# Wisconsin Department of Transportation

**Proposal #02: 1646-08-72**  
**C Westby, N Main Street Project**  
**High Echo Lane to Locust Street**  
**USH 14**  
**Vernon County**

This is Addendum No. 01, which provides for the following:

**ADDENDUM NO. 01**

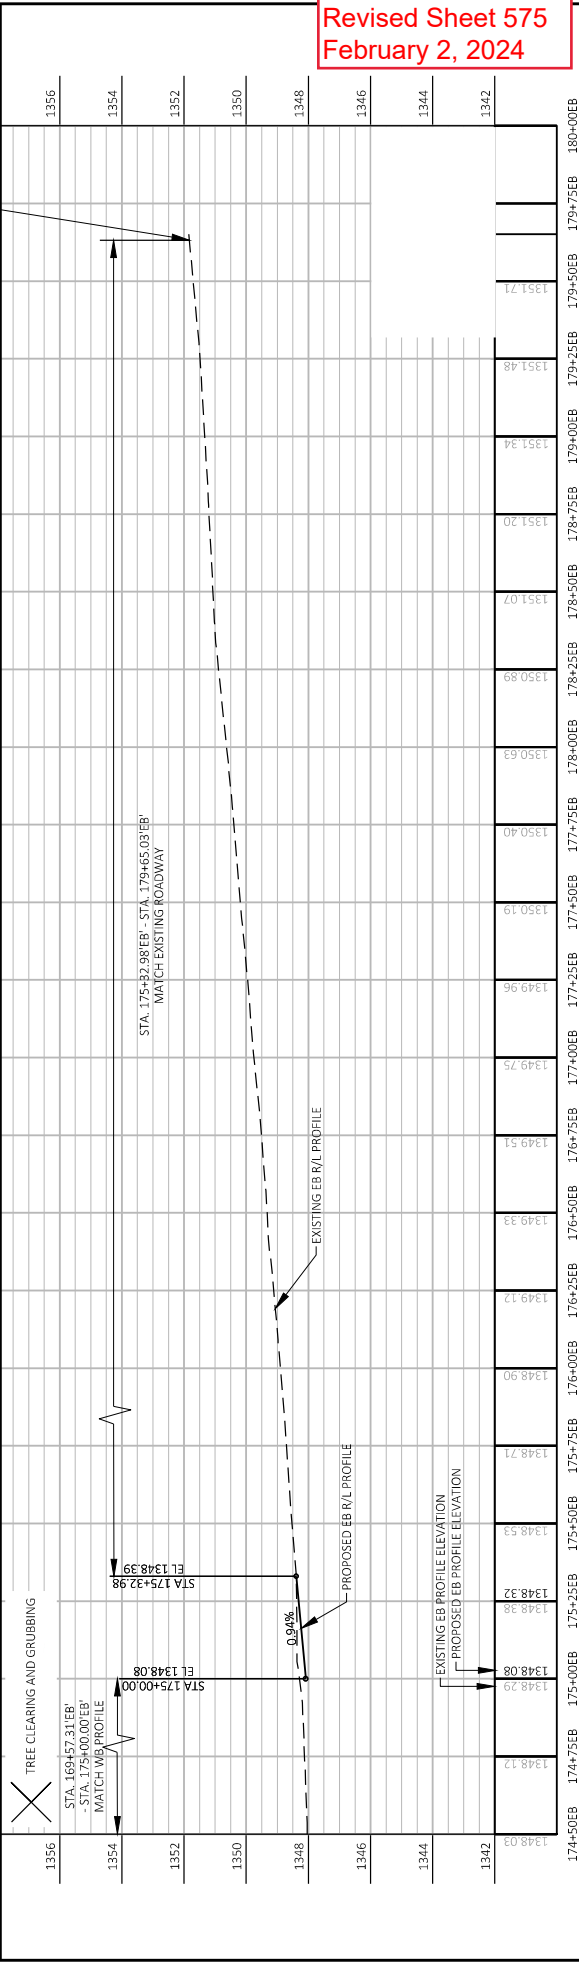
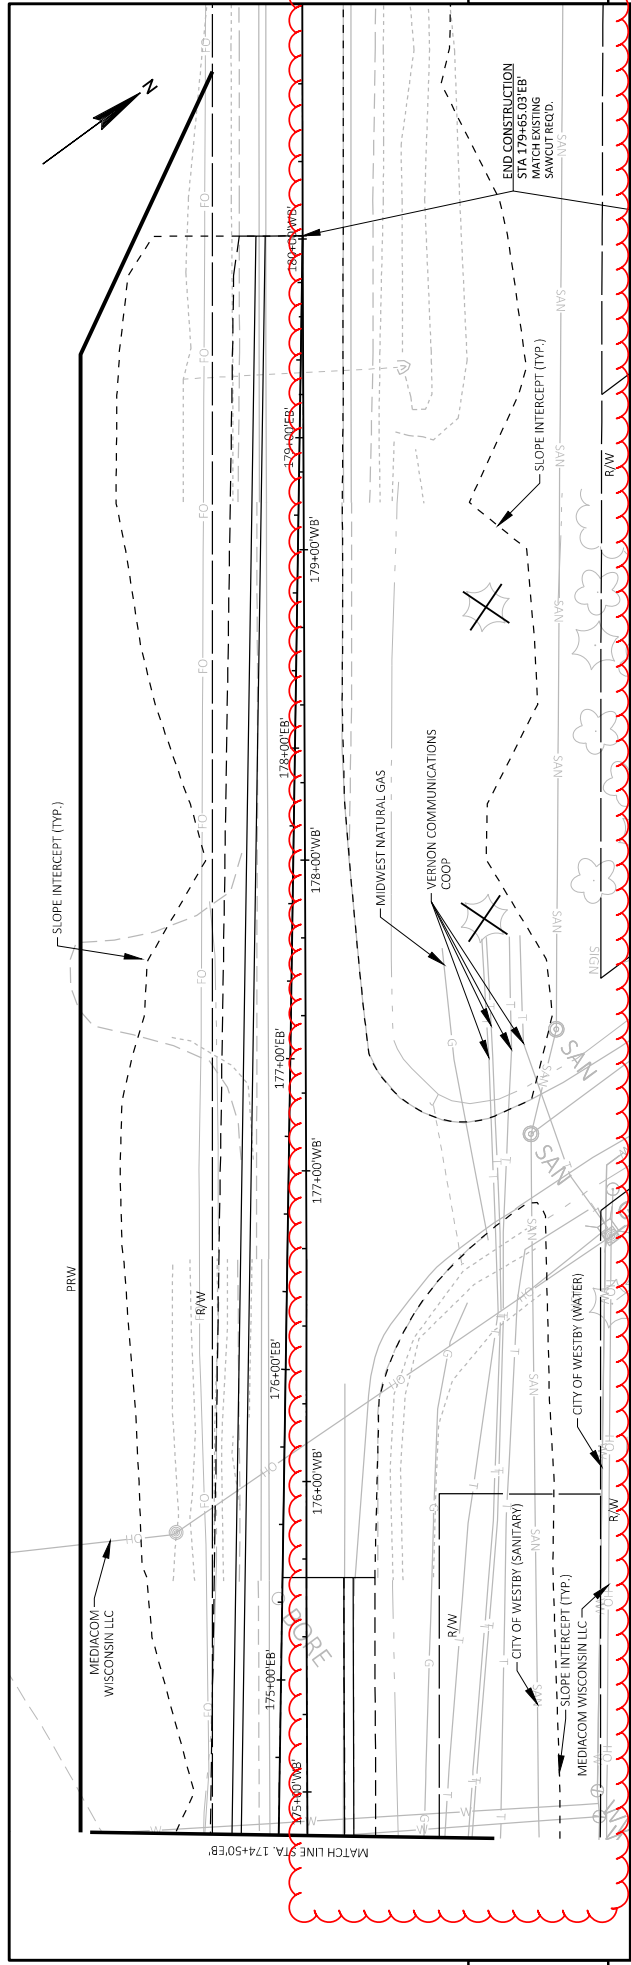
<b>Revised Plan Sheets</b>	
Plan Sheet	Plan Sheet Title (brief description of changes to sheet)
568 – 569	Plan and Profile (revised slope intercepts)
574 – 575	Plan and Profile (revised slope intercepts)

Addendum No. 01  
 ID 1646-08-72  
 Revised Sheet 575  
 February 2, 2024
